CNL-20-042

April 17, 2020

Subject: **Sequoyah Nuclear Plant Unit 2 – Exigent License Amendment Request to Revise Technical Specification 4.2.2, “Control Rod Assemblies” (SQN-TS-20-05)**

Subject: **Sequoyah Nuclear Plant Unit 2 - Exigent License Amendment Request to Revise Technical Specification 4.2.2, "Control Rod Assemblies" (SQN-TS-20-05)**

**Figure 1 - Control Rod Locations**

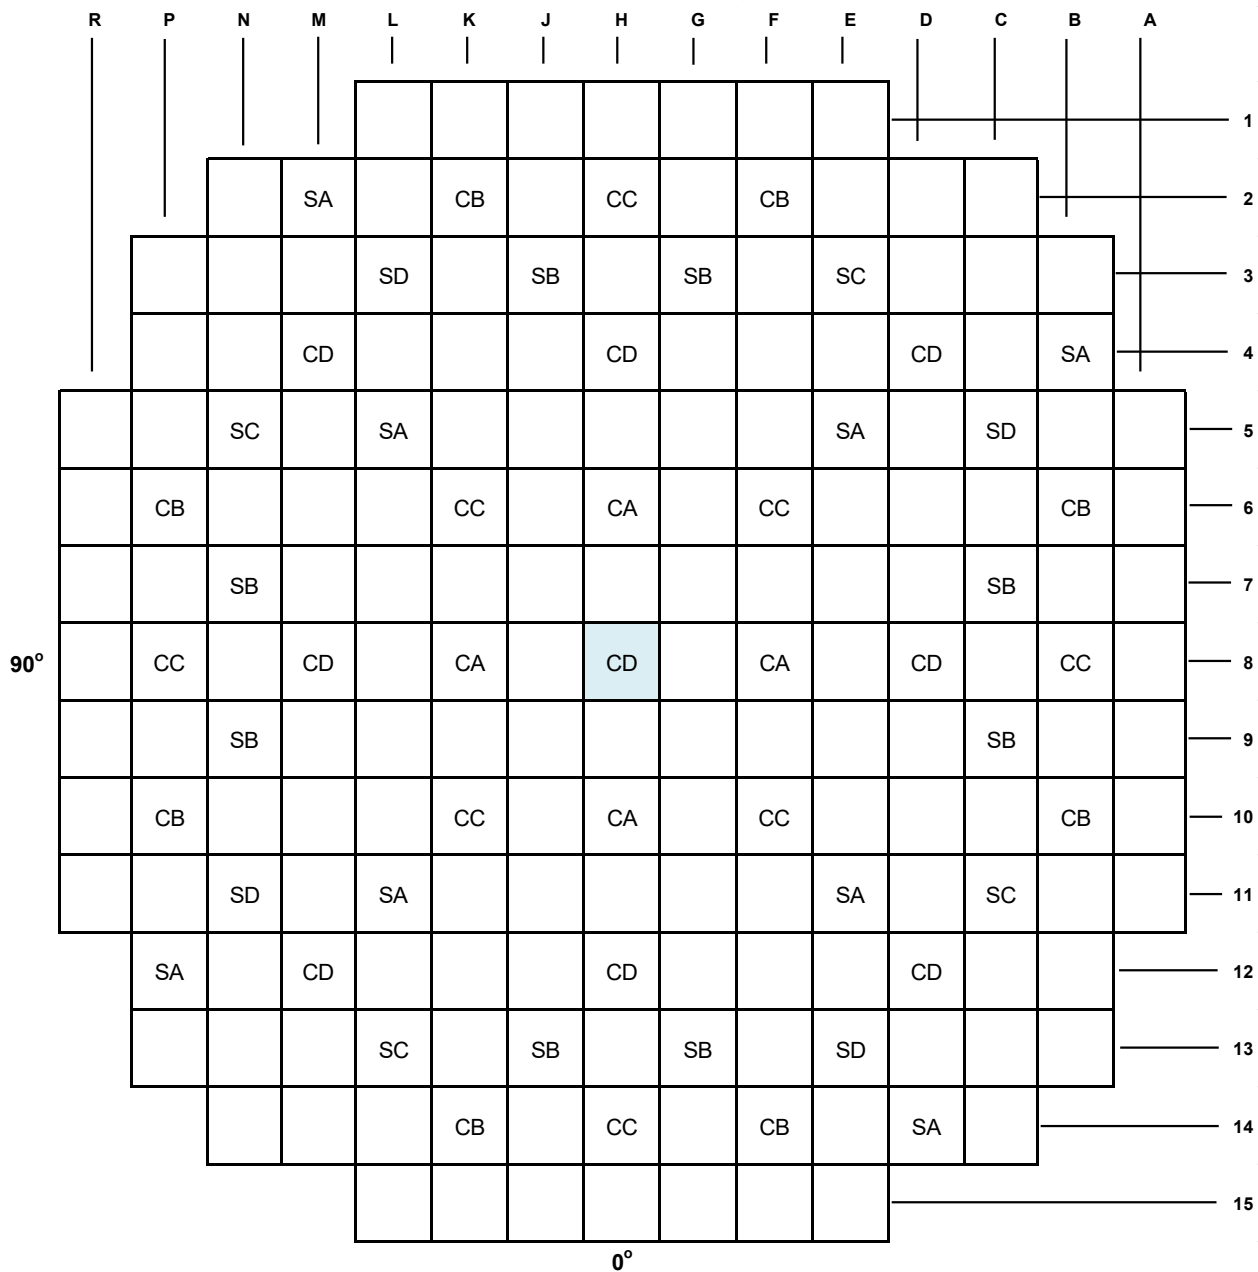
The H-08 control rod is part of Control Bank D and is located in the center of the core as shown in Figure 1. With the removal of the control rod in core location H-08, U2C24 will contain 52 full length control rod assemblies as shown in the table to Figure 1.

Note: The control rod in core location H-08 will be removed for U2C24.

Operation with 52 full length control rod assemblies (with no control rod assembly installed in core location H-08) is permitted during Cycle 24.
